Planning Commission Study Session

SUBJECT: DR18-186, VAL VISTA & QUEEN CREEK RETAIL

DR18-186, Val Vista and Queen Creek Retail: Site plan, landscaping, grading and drainage, elevations, floor plans, lighting, and colors and materials for approximately 2.12 acres, generally located at the southwest corner of Queen Creek Road and Key Biscayne Drive, and zoned Shopping Center (SC) with a Planned Area Development (PAD) overlay.

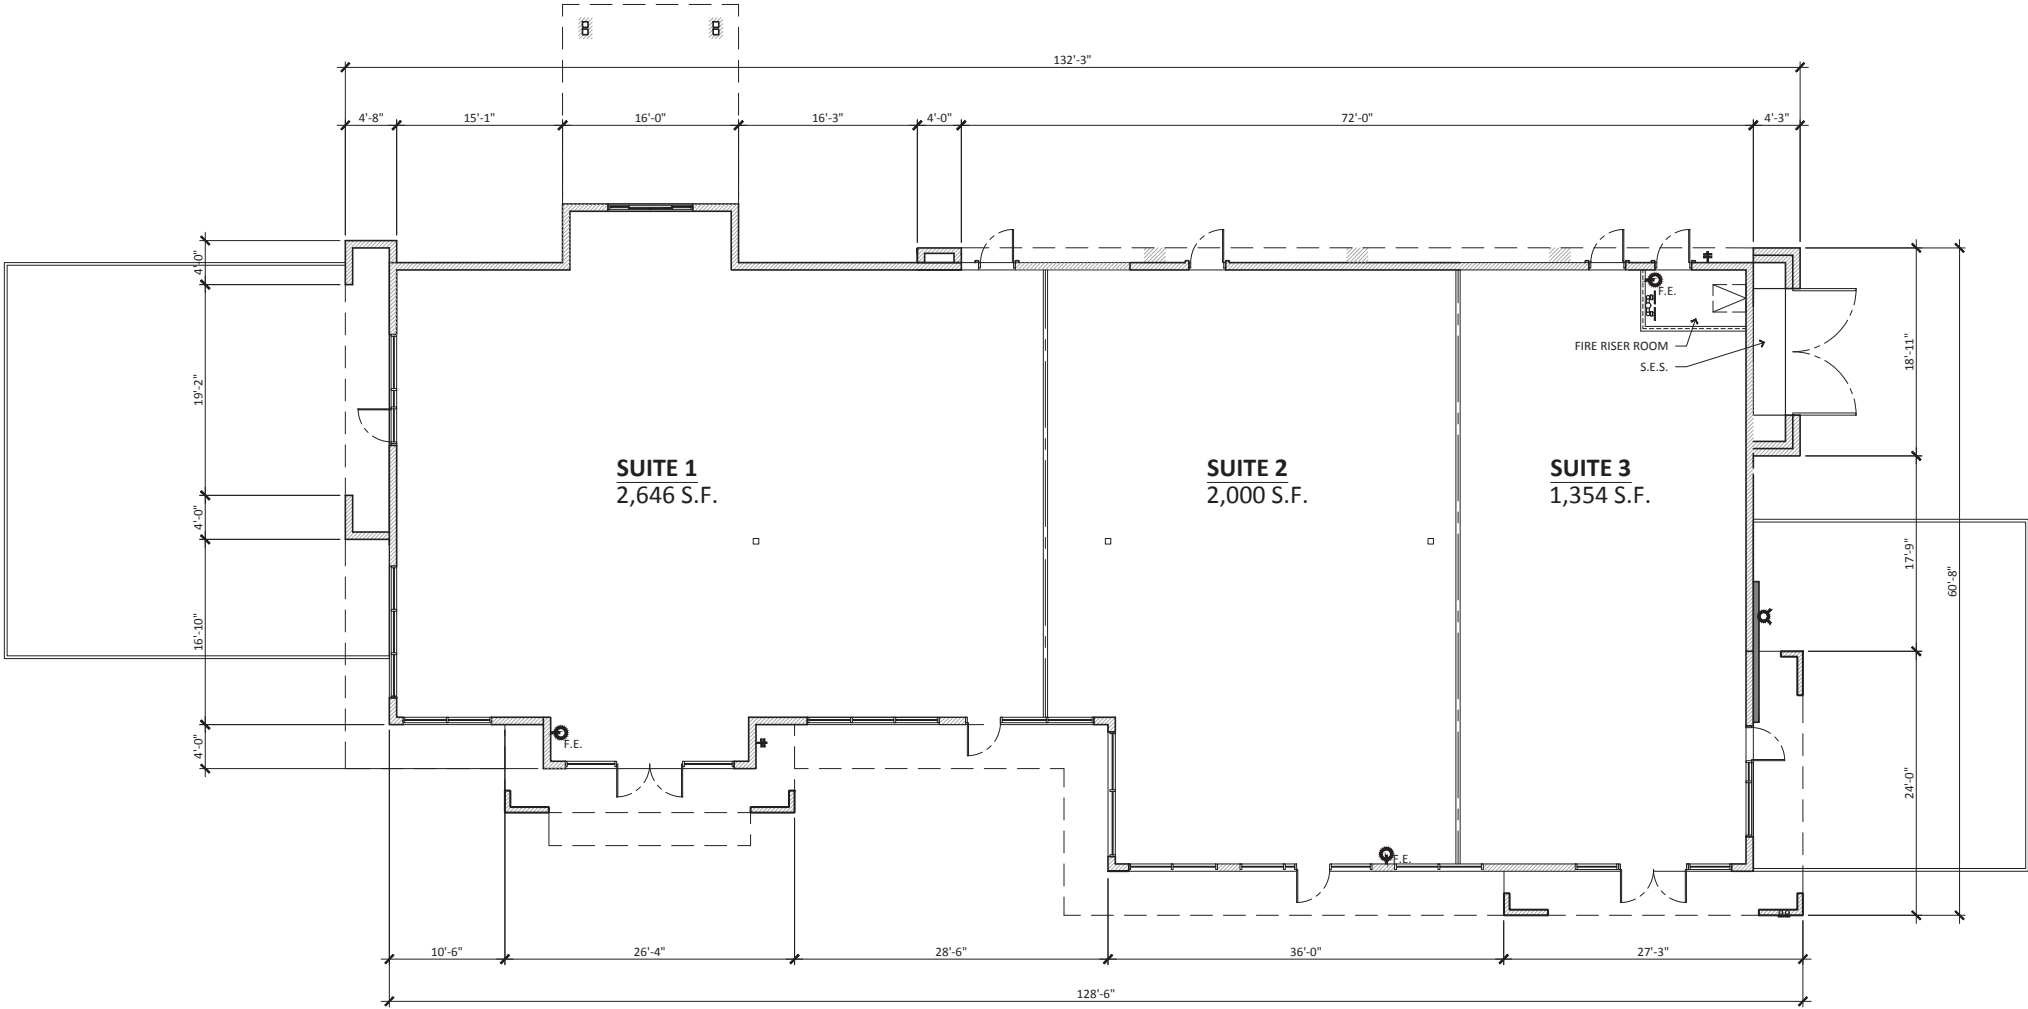
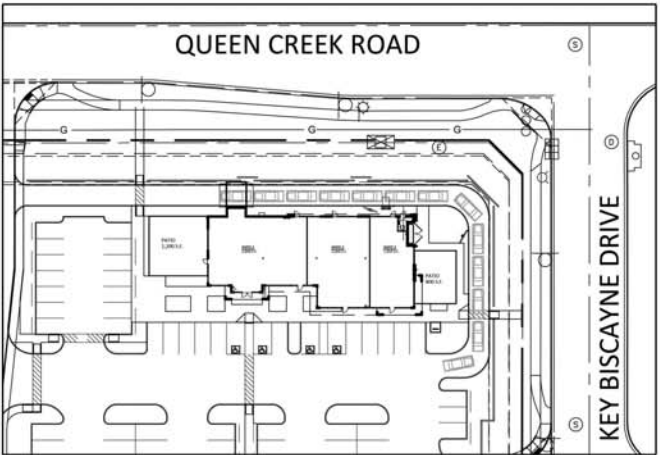
The primary building material that has been proposed is stucco painted in a range of earth toned colors. Four (4) out of the seven (7) proposed colors on the elevations are not in compliance with the Site Development Guidelines. Utilizing approved colors and materials from the Site Development Guidelines creates a more cohesive design throughout the overall site, which supports the ultimate vision for the area. For accent materials, the building utilizes stone veneer and Spanish Red roof tiles. Although the tile roofing is not included in the Site Development Guidelines, it does match the approved material palette for the care facility and its use is encouraged by staff.

The south elevation, which includes the main points of entry to the shops, is lined with large windows framed with aluminum. The north elevation, which faces Queen Creek Drive, is the most visible façade of the building and as such should be held to a higher standard architecturally. The current proposed elevation needs to provide greater visual interest. Staff recommends that the drive-thru be similar to the vertical element on the south elevation to allow for greater massing and height. In addition there is an 80' span of roofline with no vertical articulation and limited horizontal interest other than a minor 2'8" trellis feature.
